V8 XJ Series/XK

303-S514

TECHNICAL BULLETIN

Operation Of Throttle While In Closed Position – Service Action S514

ILLUSTRATION 3

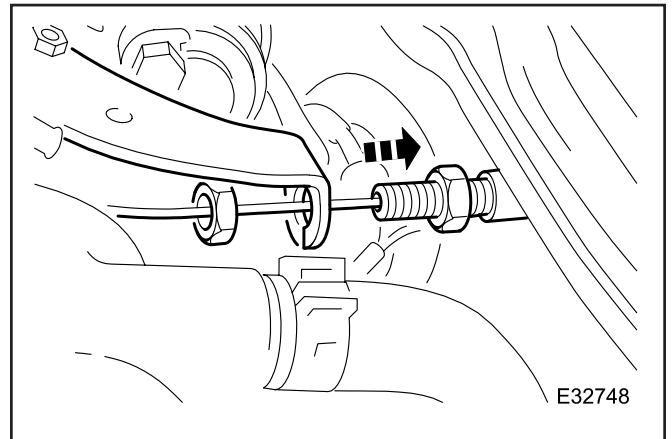
5. If installed, release the cable tie fitted around the throttle cable adjuster nut and the abutment bracket, and displace the throttle cable adjuster nut from the abutment bracket.
6. If installed, release the throttle cable-locking nut and displace the outer cable from the abutment bracket

ILLUSTRATION 16

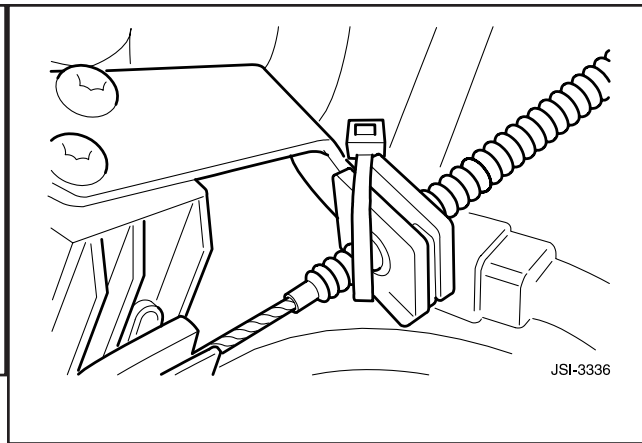
16. **⚠ WARNING: FOR VEHICLES WITH THE PLASTIC ADJUSTMENT NUT, AFTER CORRECT CABLE ADJUSTMENT, YOU MUST INSTALL A RATCHET TIE STRAP TO FULLY RETAIN THE ADJUSTER NUT IN ITS LOCATION WITHIN THE ABUTMENT BRACKET, (ILLUSTRATION 16) REFER TO RECALL ACTION R466.**
